Havant Thicket Reservoir - Phase 9 Planning Application - APP/26/00574

Visitor Centre, Bird Hide, Hub Building & NW layout Reserved Matters

I **object** to application APP/26/00574 for the Visitor Centre, Bird Hide, Hub Building and North-west layout of the reservoir site for the following reasons;

Specific concerns about the current hide design;

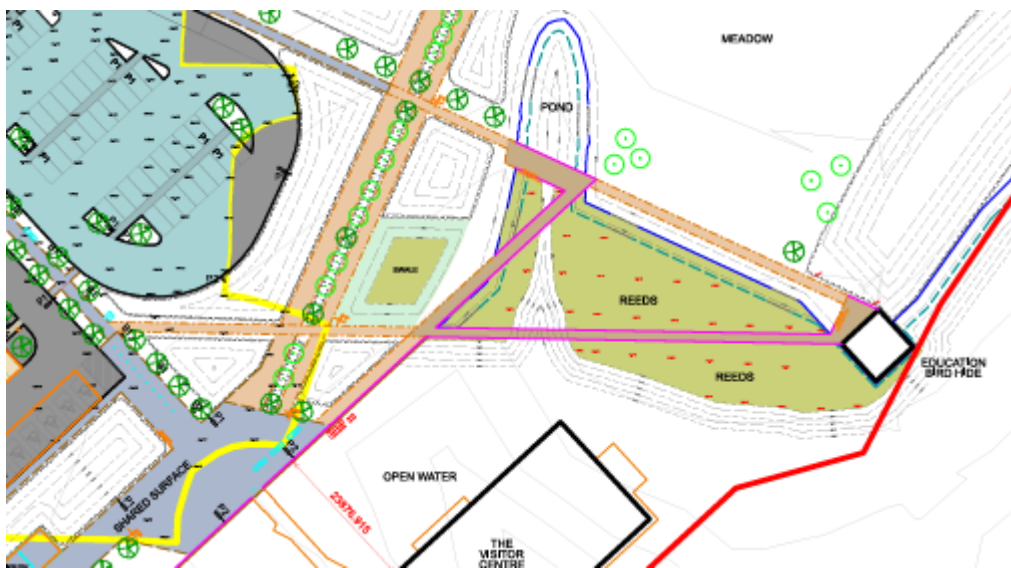
- a) The hide is too small (7.7m x 7.7m) creating a wasted opportunity to provide a more useful facility, the parameters from the original reservoir planning application allowed for a much larger building envelope of 9m x 20m (*Planning Statement page 23*).
- b) A larger longer structure orientated along the shore of the wetland in a v-shaped frontage would provide more capacity and greater viewing opportunities over the wetland.

- If the NE and SE frontages were pivoted more to be angled to the water frontage (v-shaped) the hide would provide better viewing opportunities over the wetland, especially in different light conditions.

- c) The hide is only designed for a half class of 15 pupils; there is no indication that it has been designed to be dual use (multi use) and its layout is not optimised for that. A longer hide would open up the opportunity for more seating, a second access door, and provision of a folding screen to separate off the education area for a half class when needed, as is provided at Blashford Lakes. The photos in Appendix B of the hide at Blashford Lakes show the different design/ space provided at each end of the hide to allow a multi-function dual use.

- III. Require provision of details for approval by the LPA of a Bird Hide with a larger footprint suitable for dual use by a guided group and the general public, including simultaneous use.

Left – Extract of HTR Landscape Masterplan shows no barrier/ hedge along the wetland shore

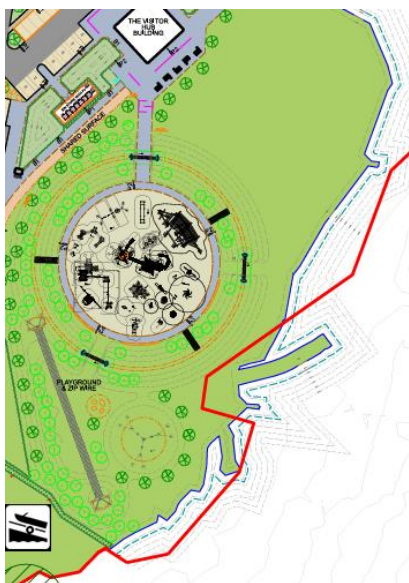
The Landscape Visualisation illustration on Page 7 and 19 of the Landscape Design and Access Statement appears to show railings along part of the water's edge near to the play area (see extract below), but there is no secure barrier (e.g. hedge with

stockmesh fence inside) that would stop children or dogs accessing the shore of the wetland conservation area. This is needed for health and safety reasons near the play area, to prevent disturbance of wildlife using wetland compartment 4, and to prevent people/dogs getting to the wetland retaining structure islands which are only a short distance offshore. Noting that the spillways that separate the islands on the retaining structure that would normally help to discourage access to the islands will be dry during reservoir drawdown, so a robust barrier is essential to prohibit access to the retaining structure islands. The railings shown on the illustration below are not a robust barrier to deter access, but not even these inadequate railings are marked on the general arrangement drawings or Landscape Masterplan (see extract below), no barrier is shown along the wetland shoreline.

- IX. Details of measures to be used to prevent dogs and people from accessing the shoreline of wetland compartment 4 and the retaining structure islands shall be submitted to the LPA and approved before the commencement of works in the NE area of the reservoir site. All agreed stockproof fences, hedges and barriers to prevent access to the wetland must be in place before the NW area opens to the public.

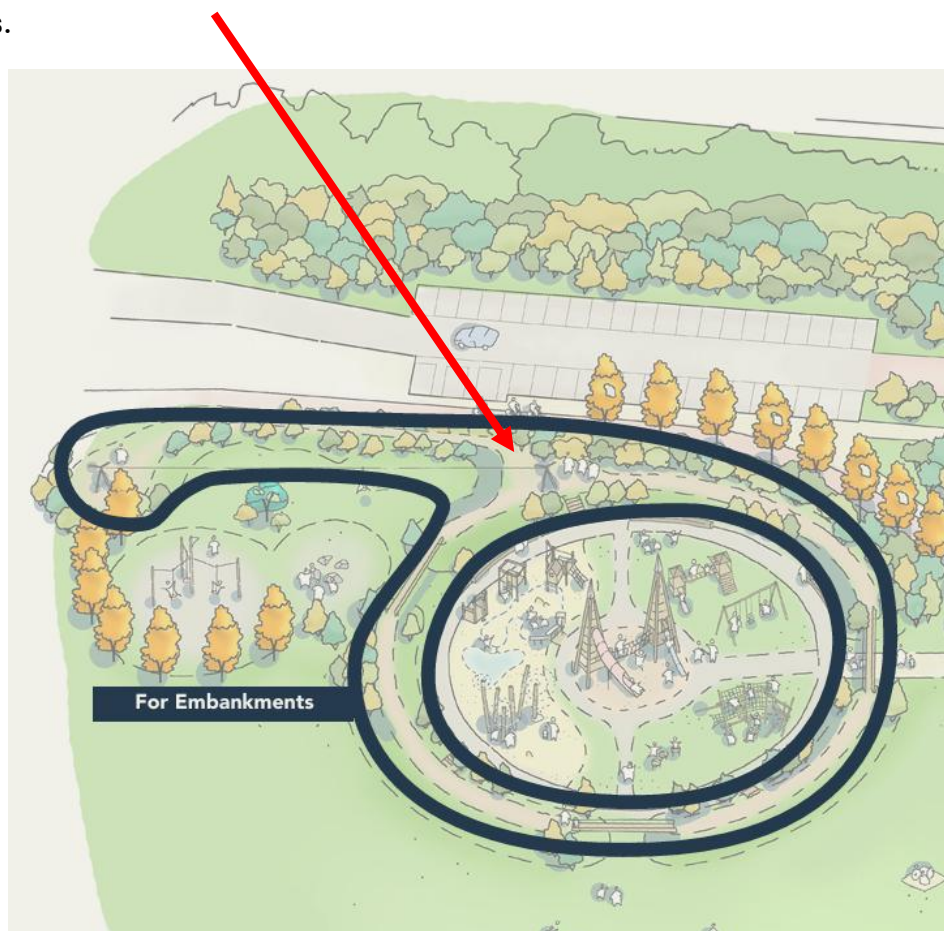
5.4 No access path to the play area where there will be an obvious desire line; The page 27 extract provided below from the Landscape Design and Access Statement shows a path to play area from southern access path which is not shown on the main drawings.

If no path is provided visitors from Warren park, or those using the crest path and maintenance track arriving from the south, must walk to the Visitor Hub building then double back to access the play facilities. The reality is that they will take a shortcut and a desire line will form through the landscaping. The path linking the path from the south to the play facilities shown on the visualisation above should be added to the general arrangement and landscape masterplan.

5.12 Biodiversity benefit/ net gain claimed in the Design & Access Statement document which includes the Landscape Design and Access Statement

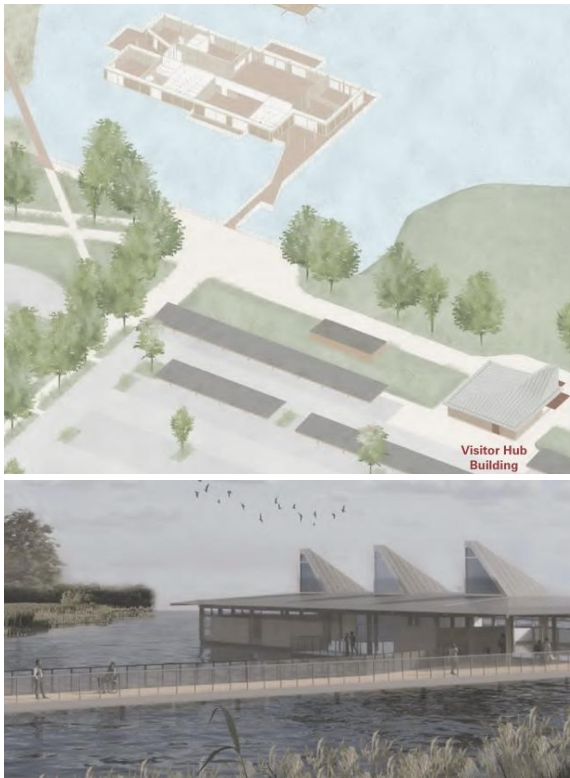
- a) Pdf page 100 suggests that the “meadow offers the opportunity to contribute 10% biodiversity net gain”. This is not the case the area where the meadow is located was already open grassland before reservoir construction commenced.

- b) Pdf page 101 suggests that “reedbed also provides compensation for the area of water covered by the Visitor Centre.” The area of the wetland lost below the building was to be high quality wetland habitat with a variety of water depths, including deep water that would only dry out during extreme drawdown events, which would be suitable for a wide variety of species. The reedbed is in a location that was already grassland prior to development, in an area of high future disturbance, where the water depth is only 100-300mm at the margins of the reservoir which will seasonally dry out. It does not compensate for the valuable wetland habitat lost below the Visitor Centre building.

Summary of the impact of alternative siting of the Visitor Centre as an island or in a shoreline location, including an assessment of the anticipated Disturbance Zones

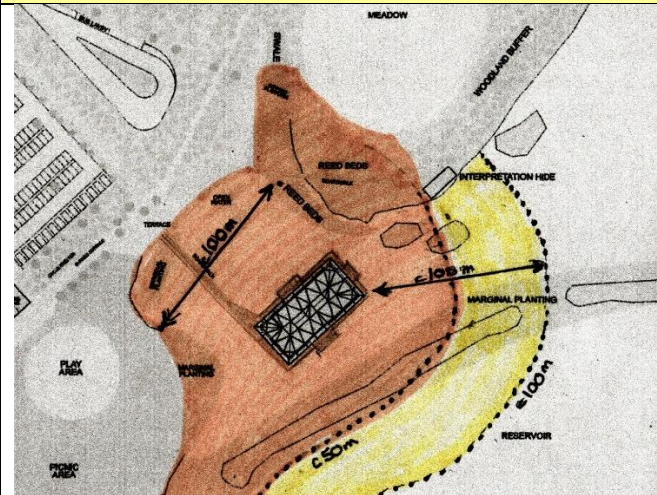
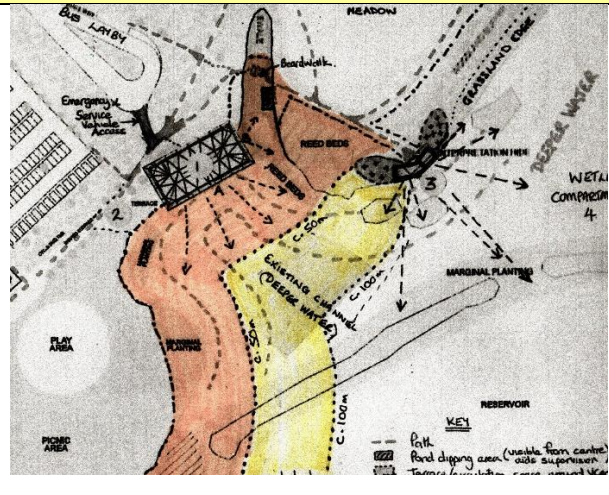
Island Visitor Centre (with external terraces)	Shoreline Visitor Centre (no front terrace)
Orange – High risk disturbance zone; area disturbed the majority of the time due to proximity to the play area, picnic area & Visitor Centre / terraces. Likely to see species that tolerate disturbance and can become habituated including; coot, mallard, mute swan, Canada goose, black headed gull & herring gull.	
Yellow – Moderate risk disturbance zone; disturbance more intermittent if very loud or sudden noise, or uncommon activity occurs. The good range of water depths and mix of riparian/ island habitats and open water should enable a greater range of species to feed and roost most of the time including; grey heron, little egret, great crested grebe, little grebe, <i>teal</i> , gadwall, <i>shoveler</i> , <i>wigeon</i> , tufted duck, <i>terns</i> , <i>redshank</i> , <i>black-tailed godwit</i> , <i>ringed plover</i> & kingfisher, as well as snipe and Mediterranean gull which previously used the reservoir site. (Species in <i>italic text</i> are qualifying species for nearby Langstone & Chichester Harbour SPA)

ensures the wetland habitat is disturbed so species available to view would be extremely limited (wasted opportunity)	a great 'wow' visitor experience. Space at rear taken up by toilet, kitchen & offices so does NOT need great views.
Long boardwalk (c.25m) over water for access to the visitor centre maximises disturbance to the wetland as noise of people & silhouettes breaking the skyline is guaranteed to scare off wildlife. Noise of trolley wheels carrying supplies & wheelchairs over boards (hit & miss noise) will add to the disturbance.	Excellent screened access from carpark minimises disturbance from visitors arriving, providing simple ALL ability short access to VC. Great connectivity between VC & terrace. Trolleys carrying supplies enter from rear causing no disturbance to wetland.
VC sits on top of existing valley which would have flooded to provide deeper water habitat.	Existing valley feature (see contours on map above) when flooded will provide a variety of submerged vegetation and deeper water which diving species such as tufted duck and great crested grebe could use & still be visible from the shore & VC.

Limited opportunity for intelligent design of the building to reduce disturbance as visitors, including children and dogs will be present causing disturbance outside the structure.	Intelligent design in location and layout can minimise impact on wetland. For example, sealed windows on south & east facades, vents can be directed away from wetland, building can help screen noise from the terrace, fencing & low hedging along shore can facilitate great views but stop dogs/ children disturbing the wetland shore.
Very exposed location of VC/ café and SW prevailing wind will make it impossible to stop litter blowing into the wetland (paper cups, napkins, drinks cans, wrappings & stirrers)	VC location sheltered by trees/ landscaping reducing the wind and risk of litter being blown into the wetland. Litter blown off tables can be captured on fence/low hedge around terrace on shore.

Map 1 - Island Location - Visitor Centre as an island

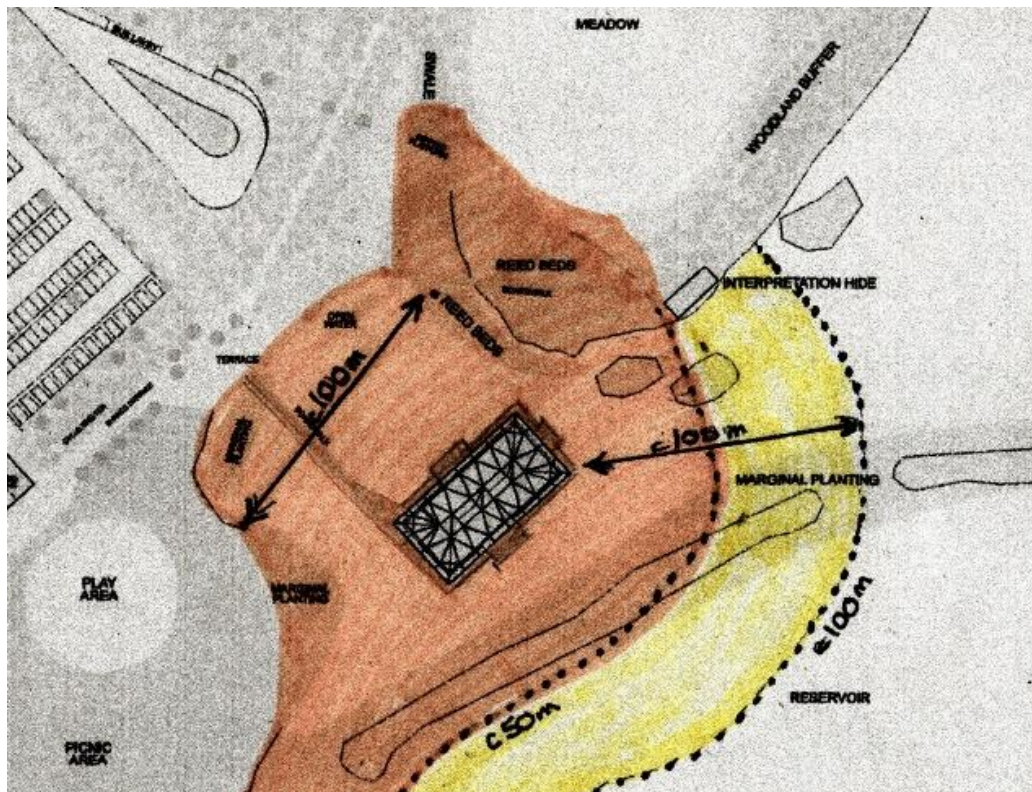
- b) The offshore location results in the loss of valuable wetland habitat below the footprint of the Visitor Centre building and extends the zone of disturbance much further out into the wetland than is necessary. This is demonstrated on the maps provided in Appendix D which show the smaller zones of disturbance if the Visitor Centre had been located on the shore of the wetland, including causing less disturbance to the area of water in front of the bird hide. The zones of disturbance for the shoreline and island Visitor Centres were produced with the help of a wetland specialist with more than 30 years' experience of creating, managing and monitoring freshwater wetlands in South Hampshire.

Map 2 - Shoreline Location - alternative siting would reduce disturbance of wildlife and impact on the wetland (located within permitted VC area box in outline hybrid permission)

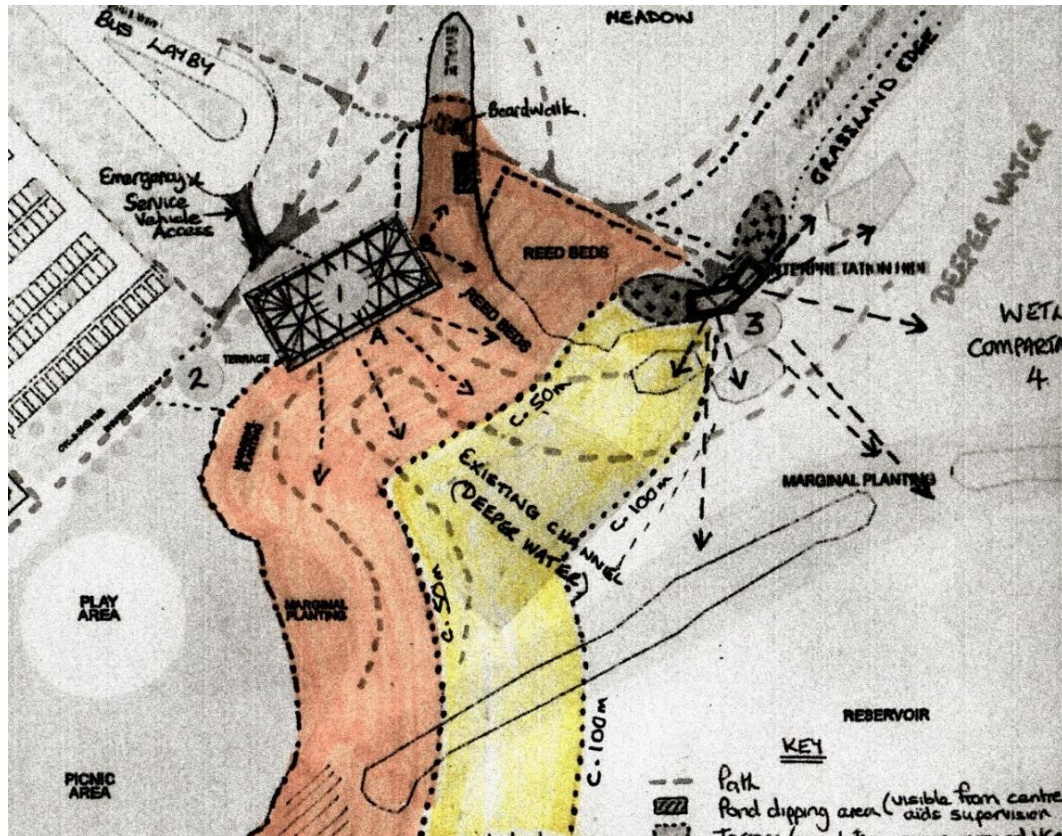
Note 2: In both location scenarios it is assumed the Education/ Interpretation Hide is screened on both sides to minimise disturbance in front of the hide.

Inadequate allocation of space for Grounds Maintenance Storage & Workshop in 2026 planning application

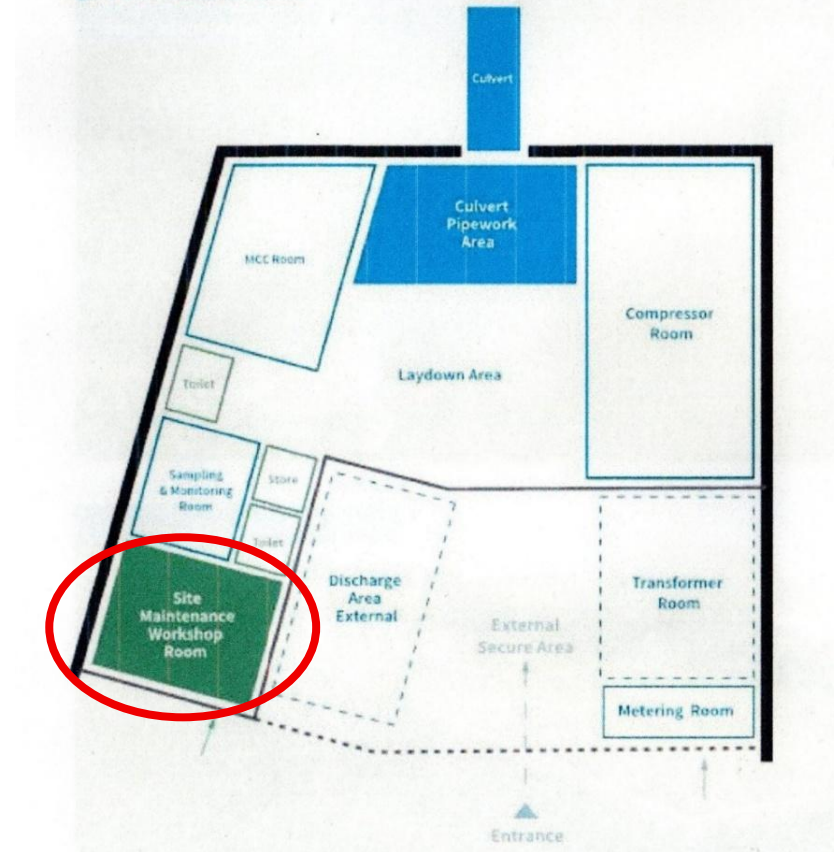
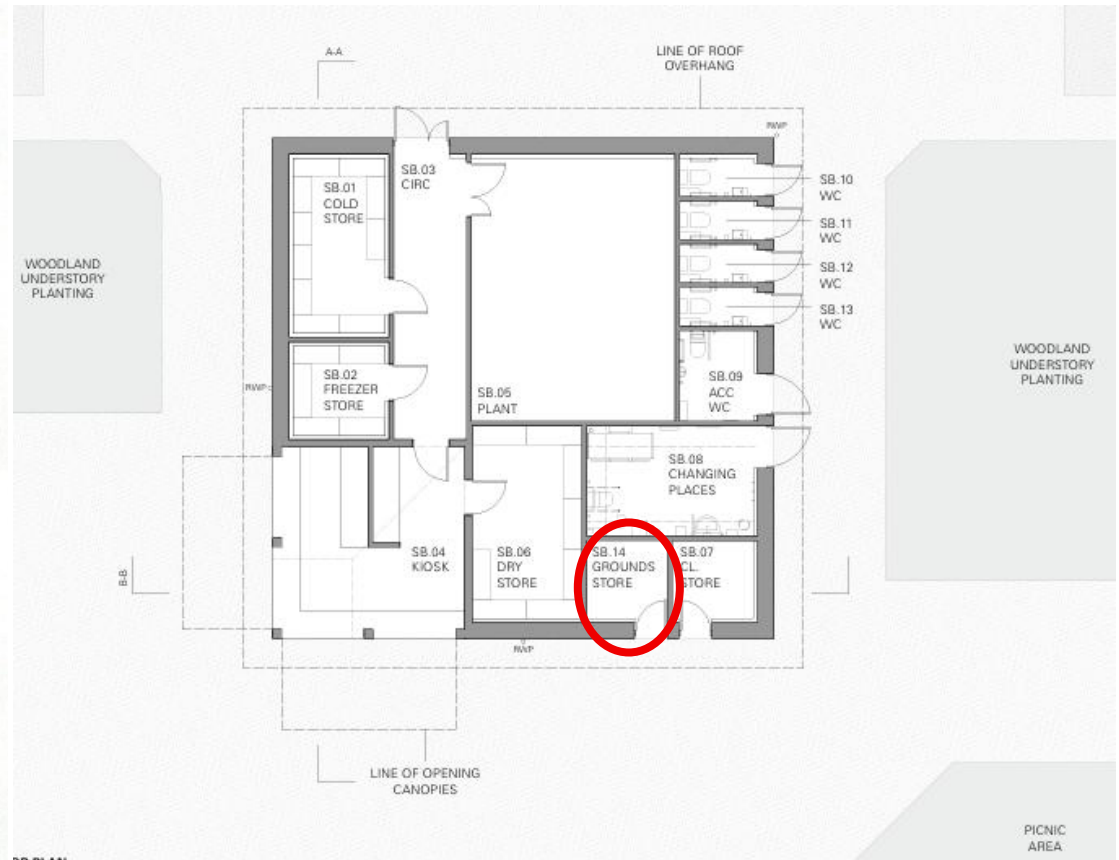
includes only a very small Grounds Store (no workshop space)

The 'Grounds Store' shown within the 2026 Visitor Centre Hub building should have been designed to replace the Grounds Maintenance Store & Workshop area removed from the Control House building layout but it is much smaller and not fit for purpose.

There will not be space in the Visitor Hub plant room as this is to be used as an energy centre and plant room serving the needs of the Visitor Centre and Hub Building.

If the LPA is minded to approve the current application for the NW corner of the reservoir, then a planning condition should be applied requiring provision of a larger Grounds Maintenance Store & Workshop at least equivalent in area to that originally shown in the hybrid outline application/ permission within the Control House building, with the layout ensuring direct vehicle access.
